Review of Planning Application 25/01708/OP

Transport Review

Client: Royston say no to Gladman

Reference: PC7908-RHD-XX-ZZ-RP-R-0001

Figure 2-3: Extract from Design and Access Statement p36 (Figure 31 – Indicative Section)

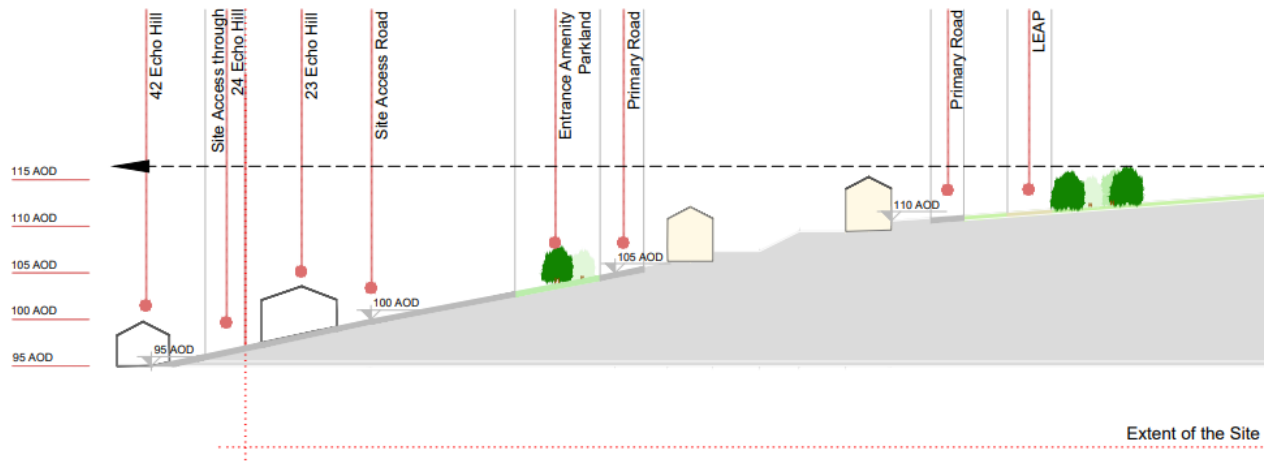
- 2.3.8 The gradient between the new proposed access on Echo Hill to the proposed Primary Access Road within the site can be calculated from the cross section. This identifies that the site rises a total of c.8m over a distance of 60m, representing a 1:7.5 gradient or a 13.3% gradient.

- **> 10%** - considered steep and potentially unsafe or inaccessible. May require steps, ramps or alternative routes.
- 2.3.10 The HCC guidance requires a gradient between 1% and 5% long-fall to facilitate movement for all pedestrians. Given the steep gradient of the proposed access road, it cannot be concluded that this supports or promotes a sustainable development location, as new residents are unlikely to consider walking (or even cycling) and would simply be car dependent in accessing the site, contrary to National, Regional and Local planning policies.

Figure 2-4: Visual representation of existing site levels and potential site access road

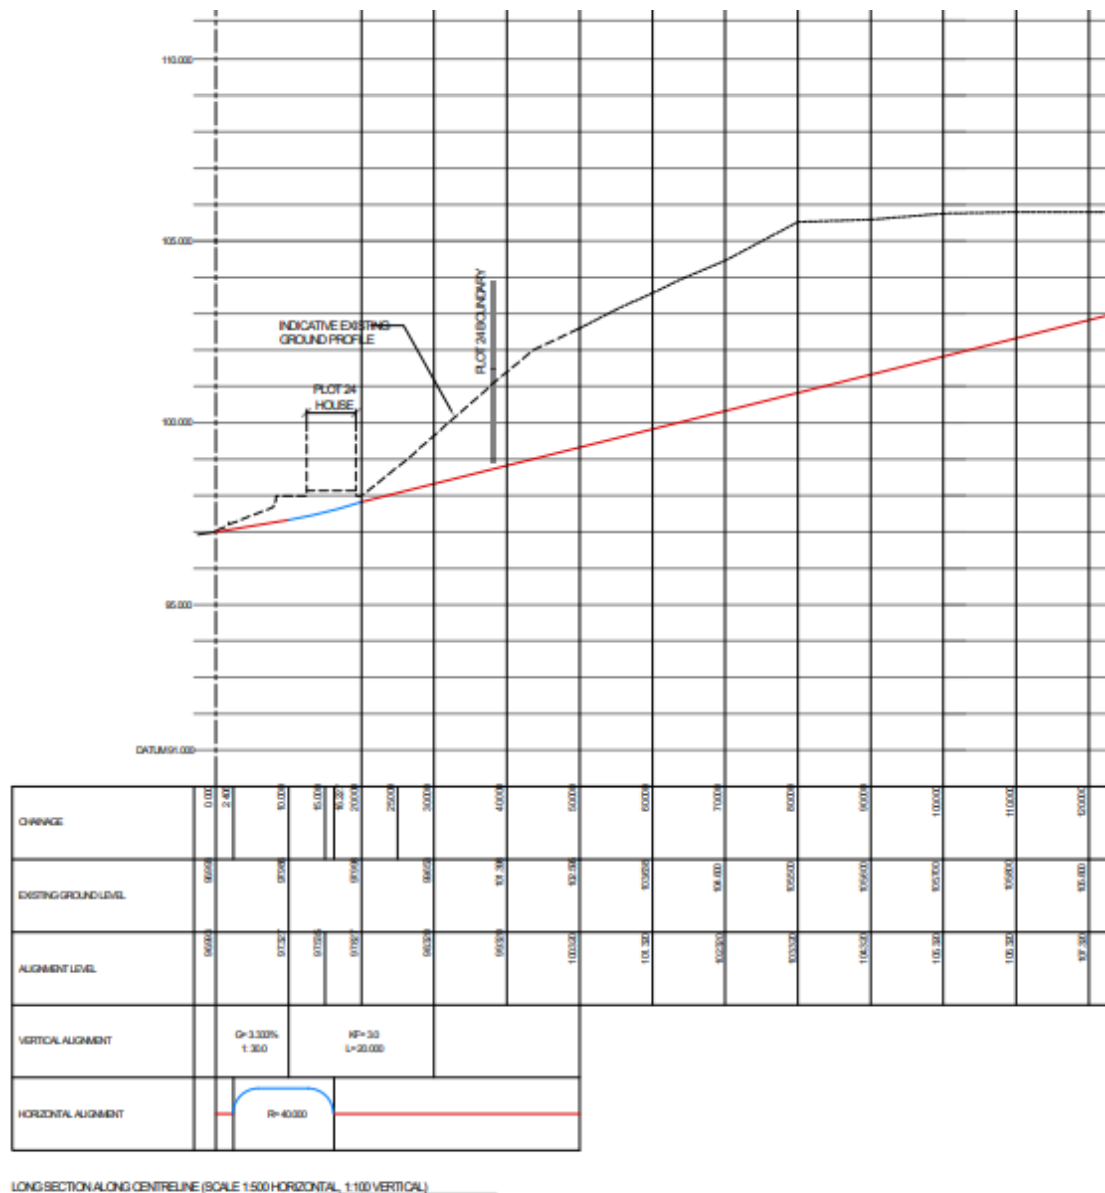
- 2.3.13 From Figure 2-4, it is apparent that substantial earthworks would be required to achieve even a non-compliant 10% gradient for the site access road. It is calculated there would be approximately 2.5m height difference between the level of the access road and the existing rear boundary of No. 24. No indication has been made of the substantial structures required to retain the adjacent properties in the design of the access road as part of the current submission.

- 2.3.14 Based on the assessment undertaken, substantial information is lacking from the current submission to prove that a viable development access can be achieved. The proposed 16% gradient is certainly not suitable. Delivery of a compliant 5% gradient would require extensive earthworks and retaining structures, that have not been included within the application.

Proposed Development Access Road

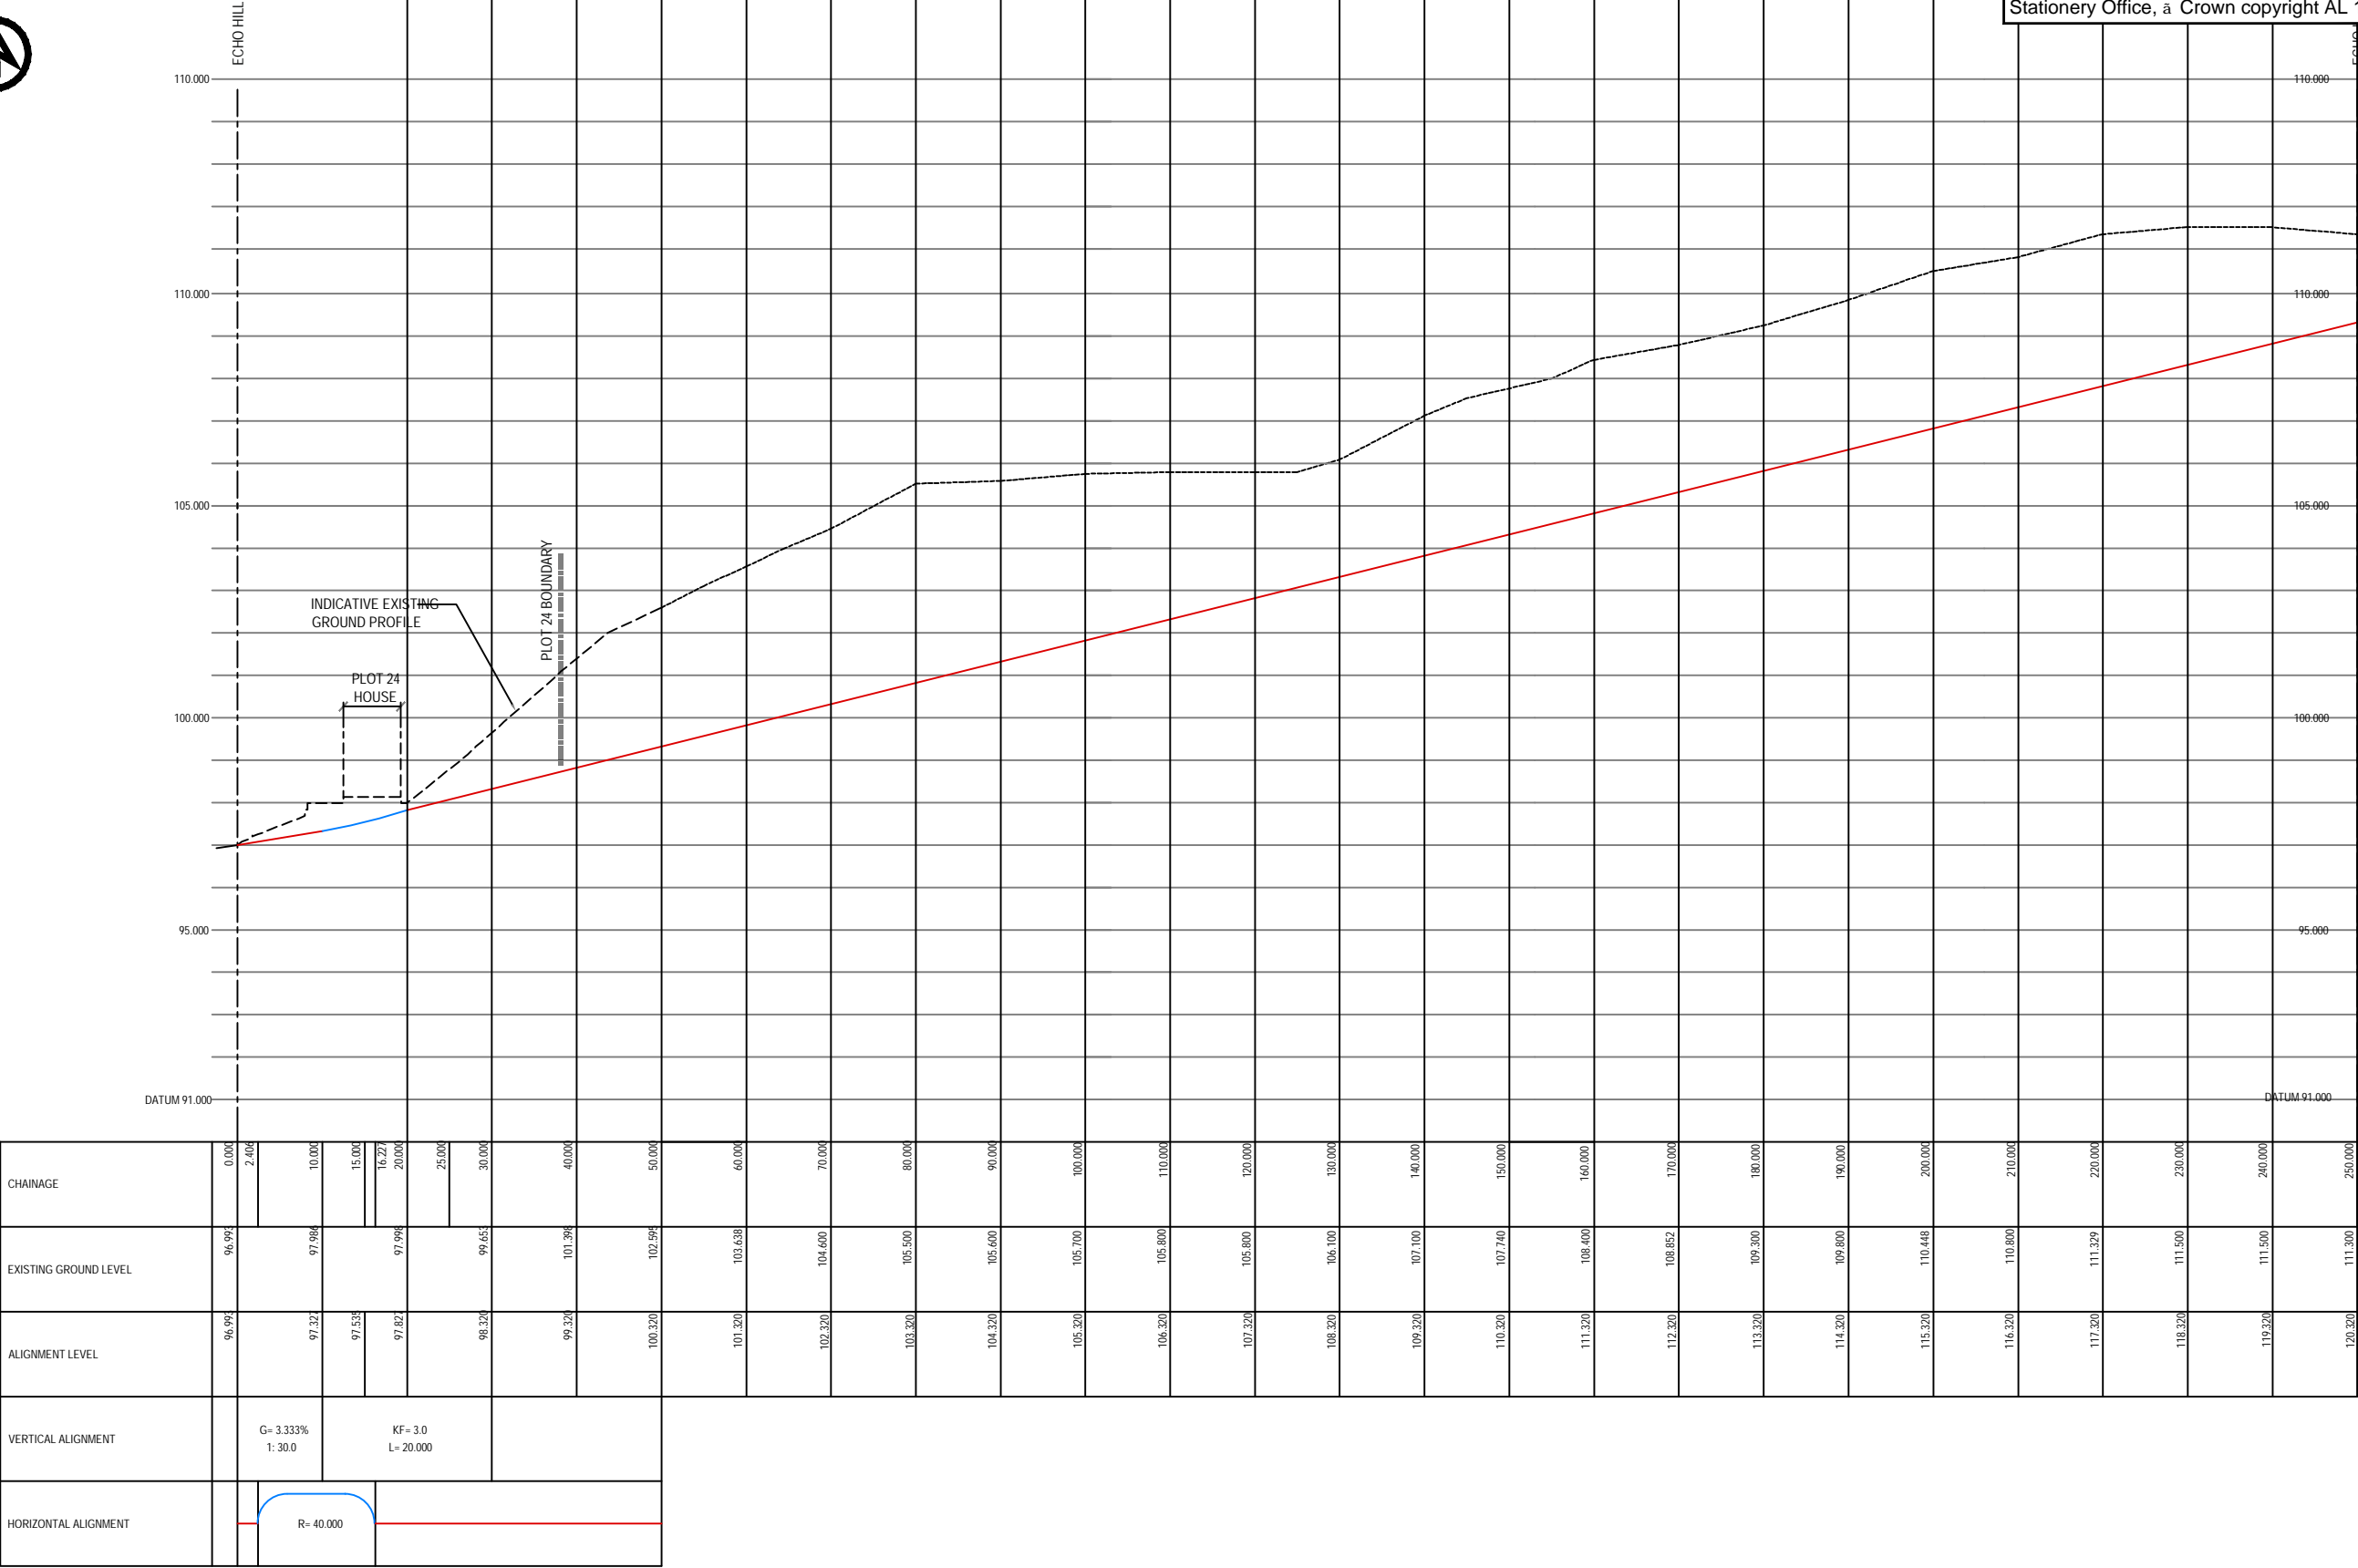
- 2.3.11 Haskoning undertook a comparison of the gradient of a compliant access road against the existing site levels, as shown in **Appendix A**. The exercise was undertaken utilising the topographic survey contained within the Flood Risk Assessment and Surface Drainage Strategy that accompanied the refused 20/00744/OP application. Given existing site levels remain consistent then the previous topographic survey is the most robust starting point.
- 2.3.12 Figure 2-4 summarises the review, with the black line showing existing ground levels whilst the red line shows an indicative vertical alignment of the 10% carriageway long-fall proposed for the refused 20/00744/OP application.
